RSB Industrial Ltd (Extension)

Plot: 32-34, Sector: 04, Road: 04, CEPZ, Chattogram
(22.282693, 91.774712)
12 October 2023

Observation

Column layout plan

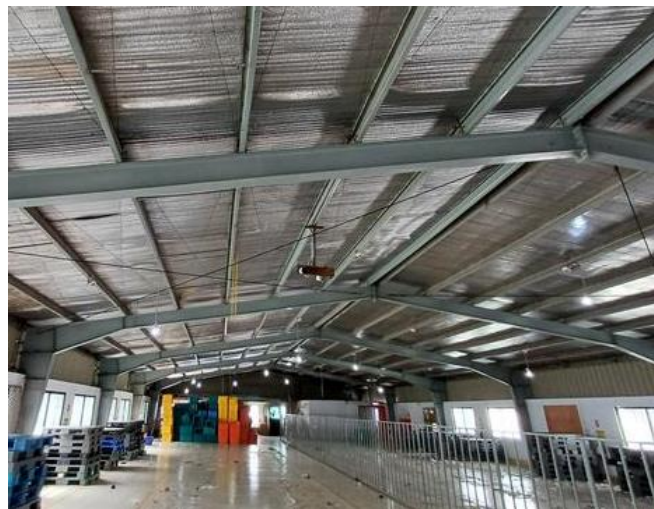
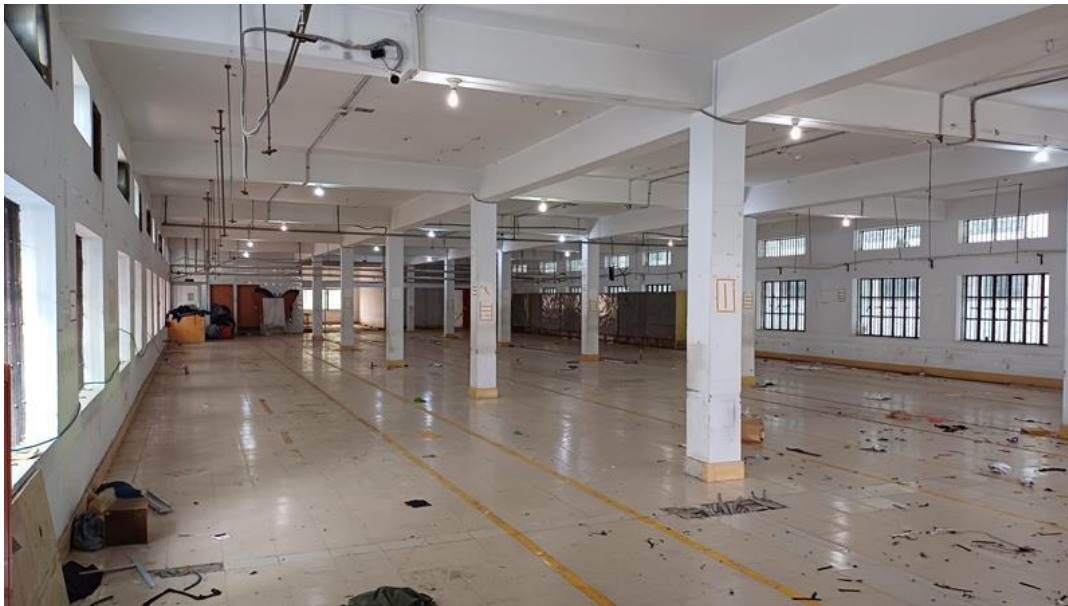
High stress in column

live load considered 2 kPa

Cursory calculation indicates that columns in the marked area found stresses above the normal design limit considering NTPA live load requirements. Live load considered on typical floor 2 kPa. Building engineer is required to review the design, load and column stresses.

No load plan observed

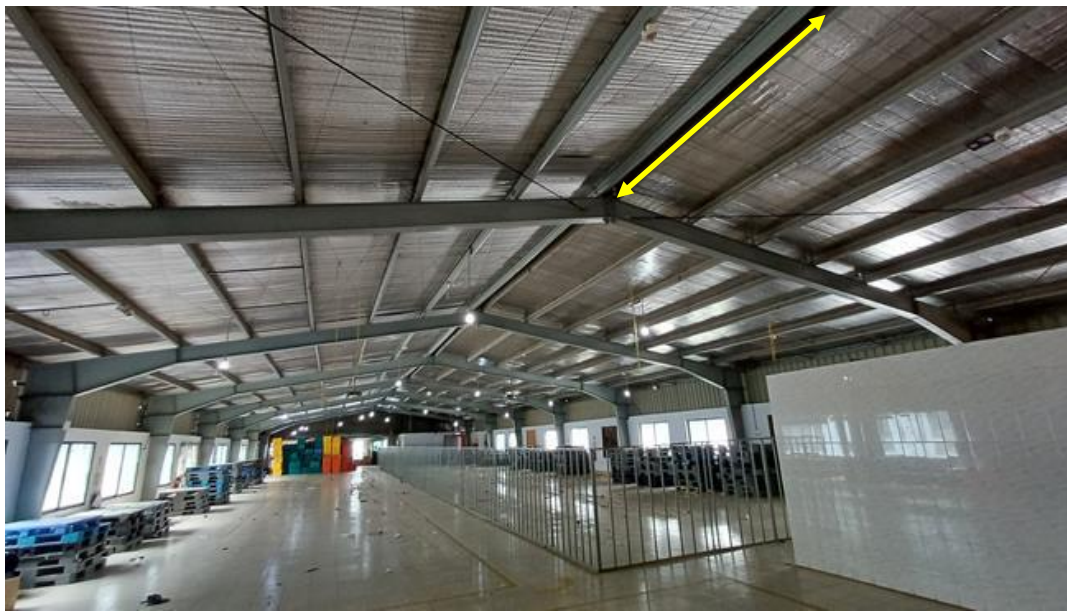
During inspection, no load plan was found on floors. Building engineer is required to produce load plan as part of EA and actively implement floor loading plan by posting on each floor and maintaining loadings.

No load transfer media provided

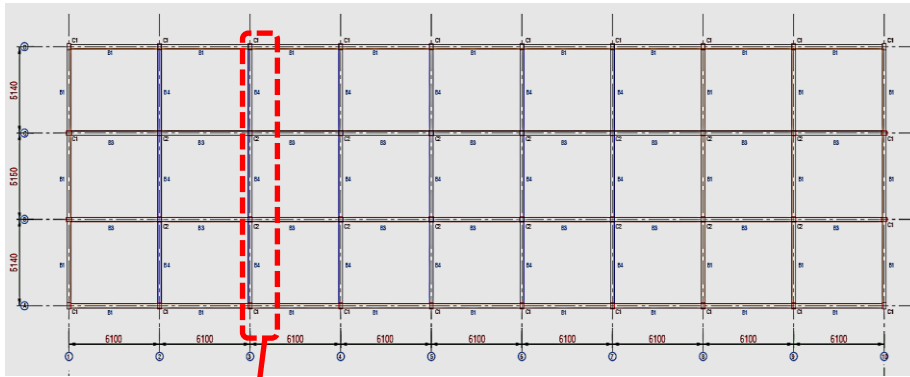
Incomplete lateral stability system

During inspection, roof bracing were found at some locations, but load transfer media was not provided from frame to frame to transfer the lateral loads. Therefore, lateral stability system of the steel frame is apparently incomplete. Building engineer is required to check the stability of the structure against lateral forces.

Discrepancies and missing information in as-built drawing

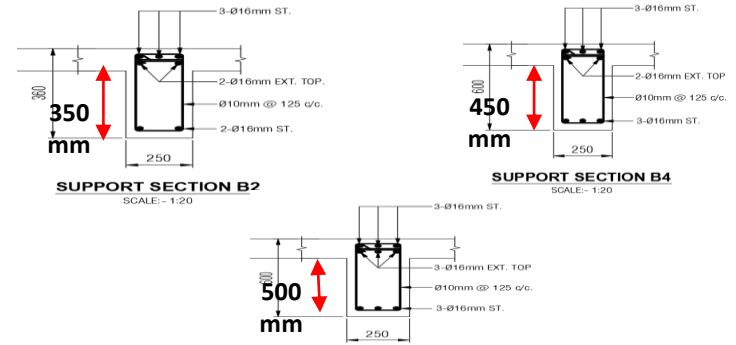
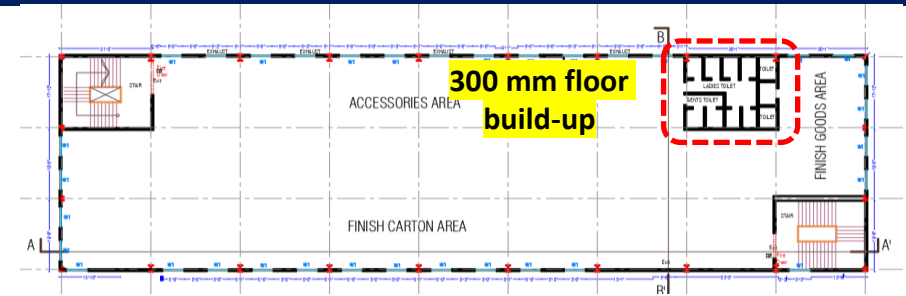
Tie beam at First floor was not shown in the as-built drawing.

Discrepancy found in beam depths at several locations (both in 1st Floor and Ground Floor). Down stand depth in B-2 beam found 350 instead of 235, for B-3, 500 instead of 475 and in B-4, 450 instead of 475.

300mm floor build-up found in toilet zone of 3rd floor which is not mentioned in the as-built drawings

Building engineer is required to update the drawing as per actual site condition and submit it to RSC for further review.

Non-engineered RO Shed

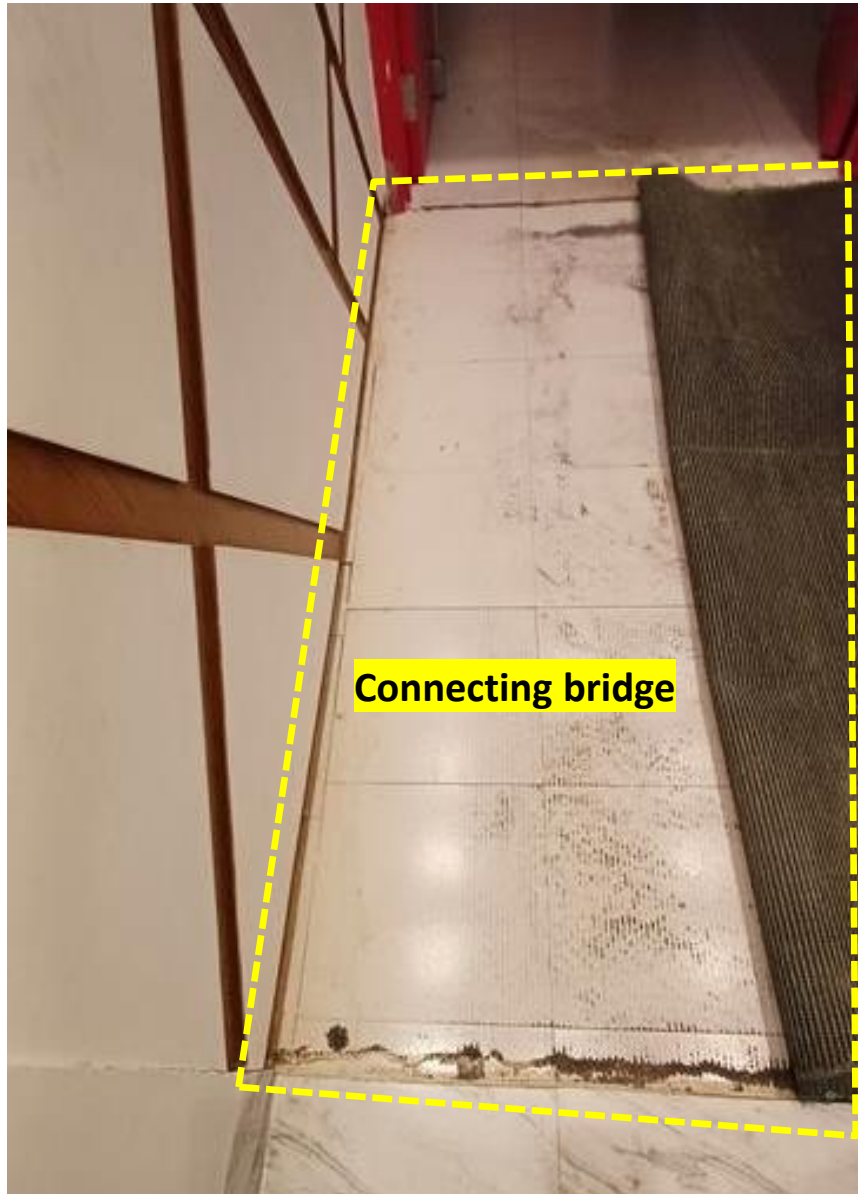
Non-engineered RO shed was observed on the roof.
Building engineer is required to check the stability of the uplift forces.
